**Study Area Characterization Work Plan Addendum Number 3
Additional Field Investigation Activities**

Site Name and Location:	Study Area, Corning, NY
Order on Consent and Administrative Settlement:	NYSDEC Project ID 851046
Corning Incorporated Project Coordinator:	Mike Ford
NYSDEC Project Coordinator:	Gregory B. MacLean
Date:	March 20, 2015

Re: Study Area Characterization Work Plan Addendum Number 3 -
Additional Field Investigation Activities;
Study Area, Project No. 851046
Corning (C), Steuben (Co)

Workplan Addendum 3 - Figure 3
 Sample Locations and
 Proposed Sample Locations
 Corning Christian Academy Property

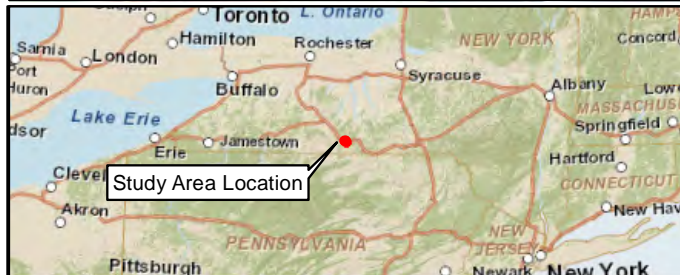
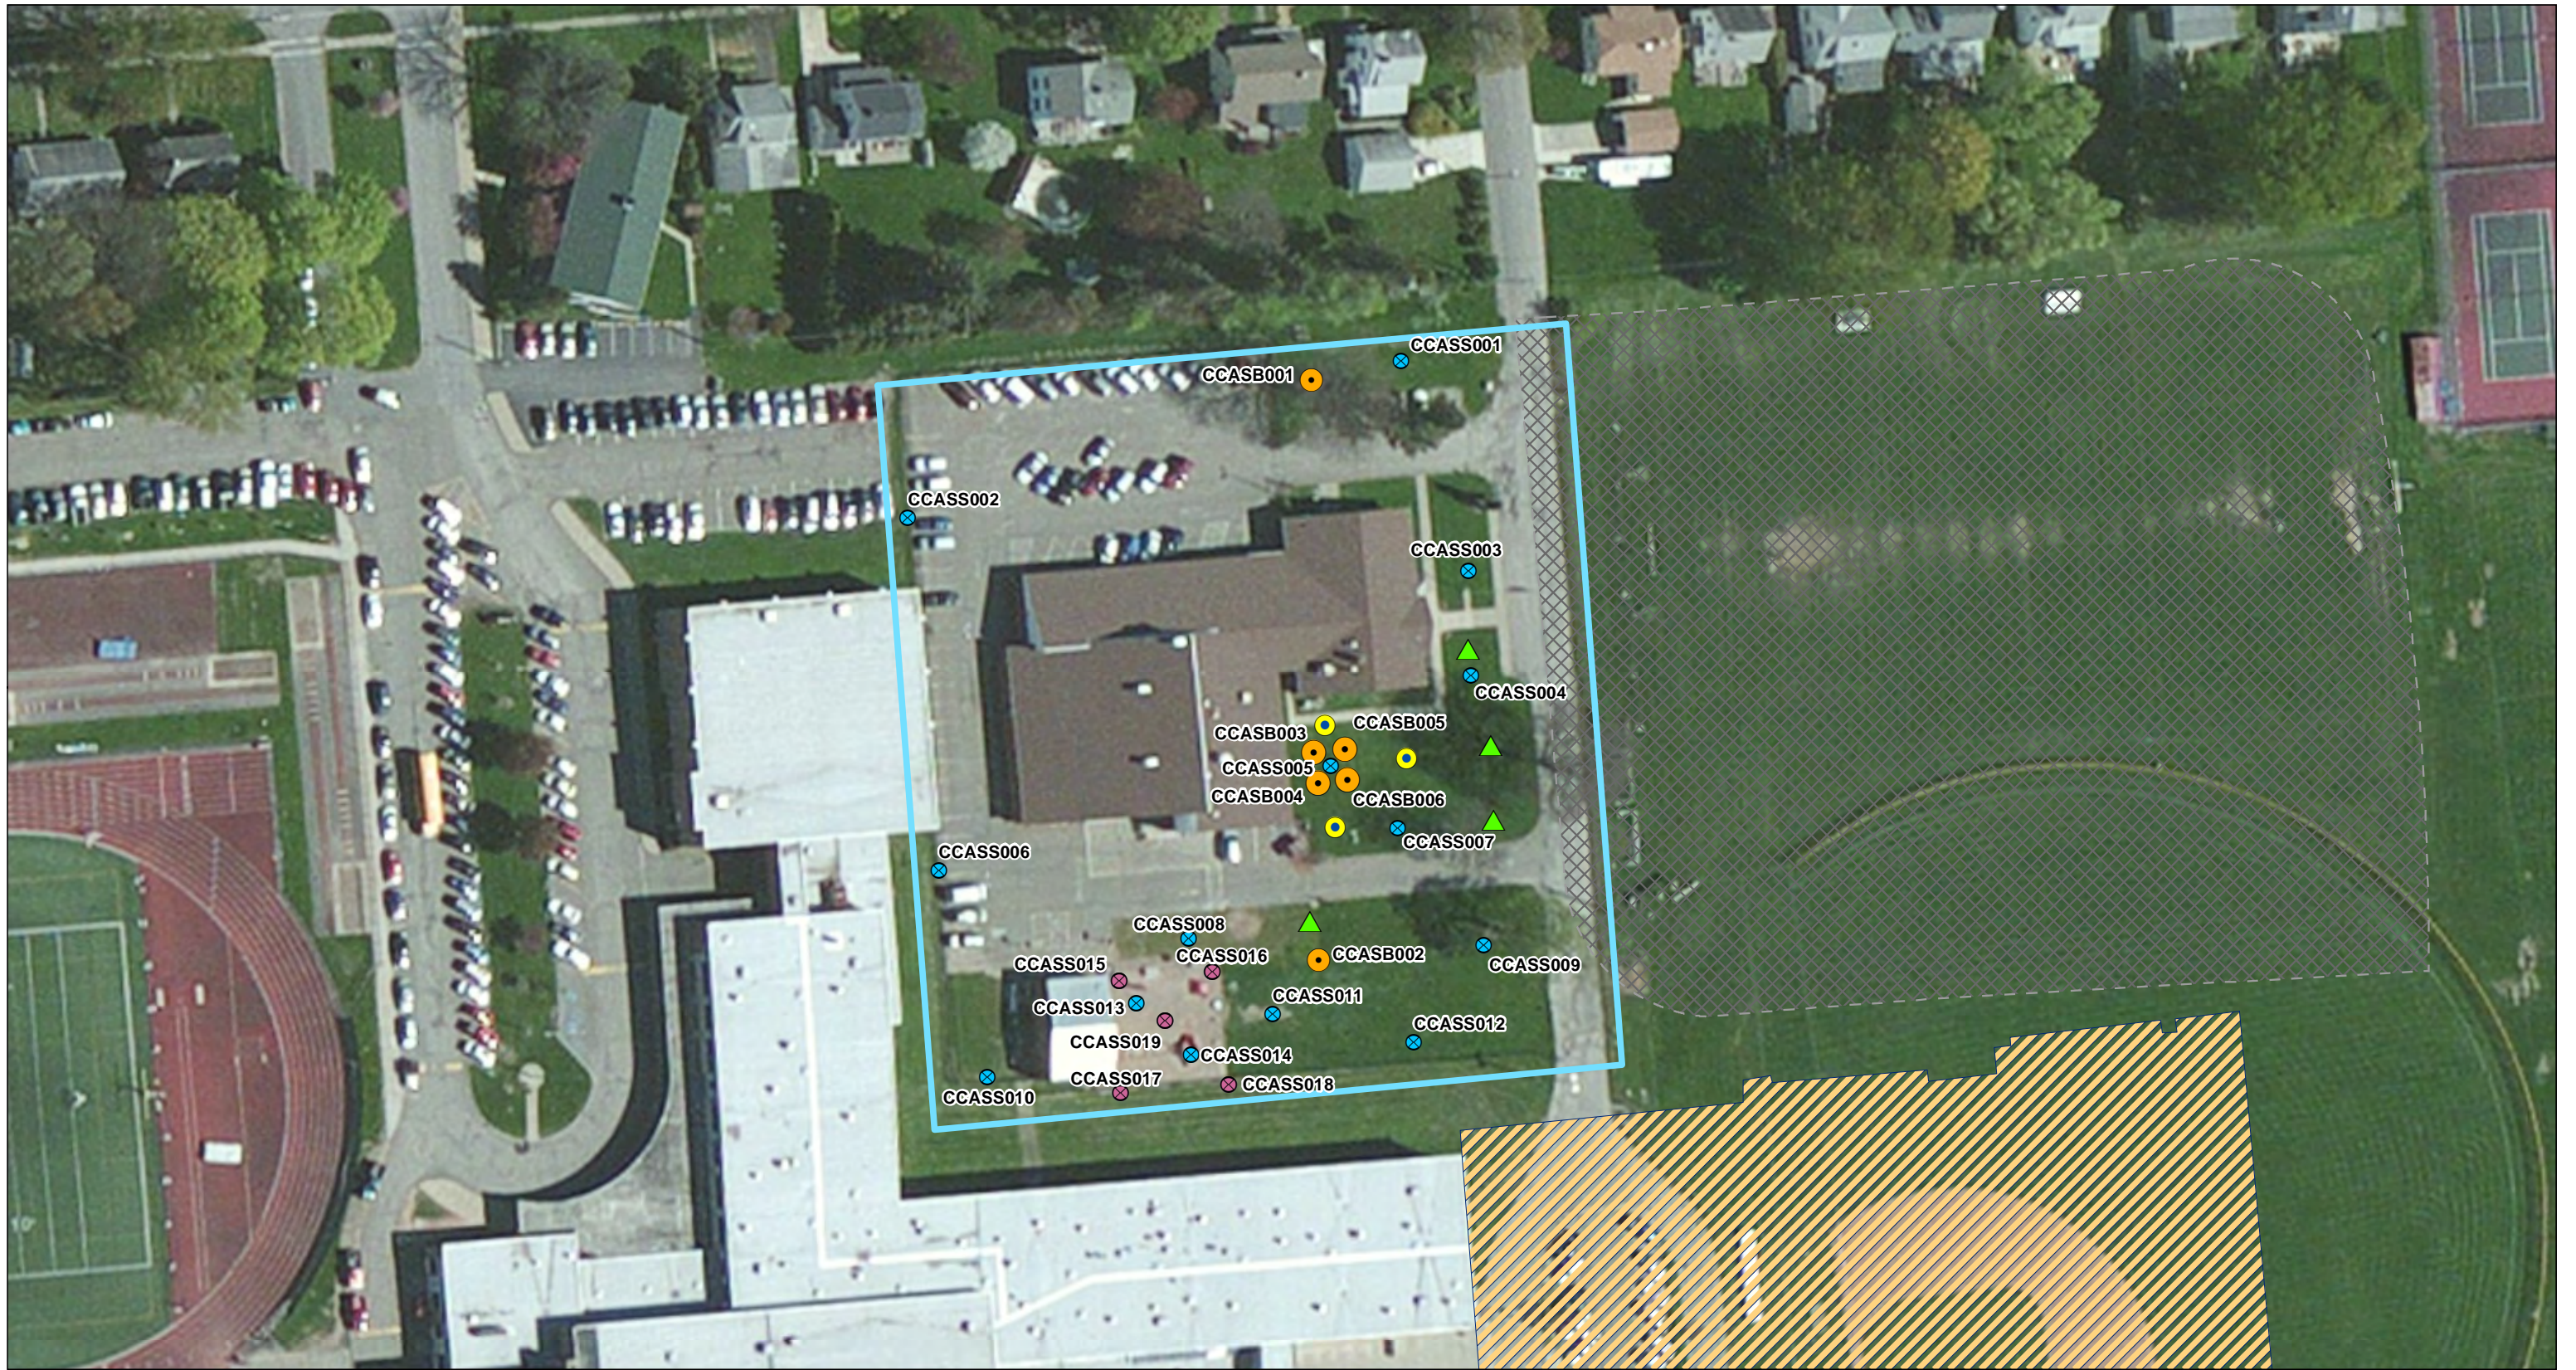
- 1) During all ground intrusive activity, the Community Air Monitoring Program in Appendix B to the Site Characterization Work Plan must be adhered to.
- 2) At the Corning Christian Property, additional soil borings are to be installed as necessary under this consent for access in order to define the extent of the layer of fill containing ash, brick, and/or glass.
